# Clonburriss Tile 2

## Stage 2 Road Safety Audit

210124-X-90-Z00-XXX-RP-DBFL-CE-0005

May 2023

**2.1.5 Problem (G5) – Waste Bin Transfer Locations**

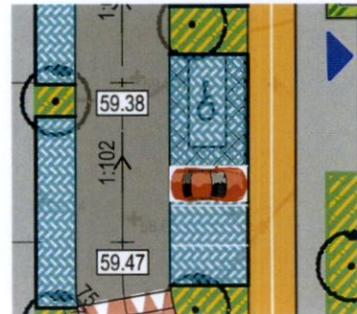
No details regarding the proposed schemes location of waste bin transfer points is provided. Should waste bins be inappropriately stored in the path of pedestrians or cyclists, this could limit the space available to pedestrians and / or cyclists which could lead to pedestrians stepping into the path of cyclists / vehicles or cyclist weaving into the path of pedestrians. This could result in pedestrian / vehicle conflicts or pedestrian / cyclist conflicts.

Ensure appropriate locations are provided for waste bin transfer which does not obstruct cycle tracks or reduce footpaths to such an extent that pedestrian must leave the footpath to move around bins. It is recommended that an appropriate route (width, dropped kerbs, gradient etc) is provided between all waste bin transfer and / or storage areas and the location of where the waste collection vehicle will be temporary parked during collection activities.

### 2.2.2 Problem (S2) – Perpendicular Parking along Cycle Track

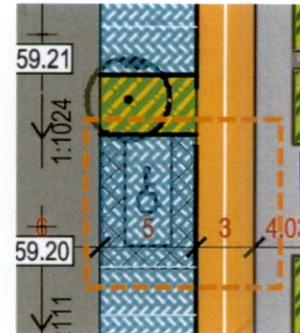
The proposed perpendicular car parking spaces abutting the cycle track could result in parked vehicles overhanging into the cycle track reducing the effective width available for cyclists. This could lead to injuries to cyclists through collisions with parked vehicles.

It is recommended that appropriate design measures are incorporated to actively safeguard the appropriate width of the cycle track to ensure no encroachment by the parked vehicles. Measures that could be considered include the introduction of a buffer area between the parking bays and cycle track or the implementation of vehicle stop blocks within the perpendicular car parking spaces.

### 2.2.4 Problem (S4) – Dropped Kerbs and Tactile Paving

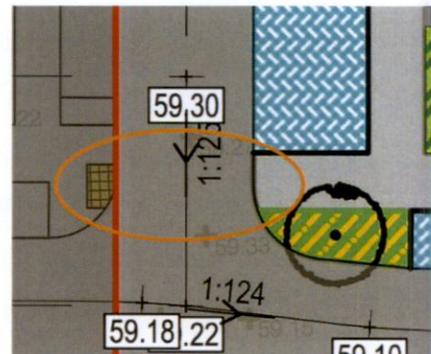
The auditors note that the corresponding tactile and dropped kerb is missing at the uncontrolled crossing in south western corner of the development. This could lead to confusion for road users particularly wheelchair users and partially sighted pedestrians who may encounter difficulties crossing the road carriageway.

It is recommended that dropped kerbs and / or tactile paving in accordance with the appropriate design recommendations is provided at (i) all key pedestrian travel desire lines that require a pedestrian to cross a road carriageway, (ii) in advance of steps, and (iii) dropped kerbs at disabled car parking bays and pedestrian routes across segregated cycle tracks.

#### 3.1.1 Comment (C1) – Existing Bus Stop Desire Line

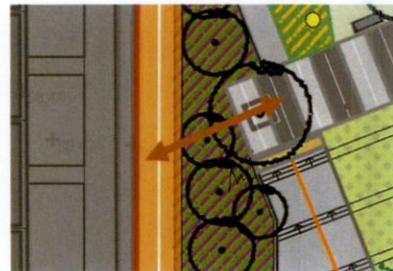
The future external road enhancements include for 2 no. new bus stops on the R113. It is unclear if these bus stops will replace the existing bus stops located further north at the train station. If the bus stops to the north are proposed to be retained, there will remain a desire line across the R113 to the north which will be intensified following implementation of the subject scheme. Accordingly, it is recommended that a controlled pedestrian crossing is provided to the north of the R113 should these bus stops be retained.
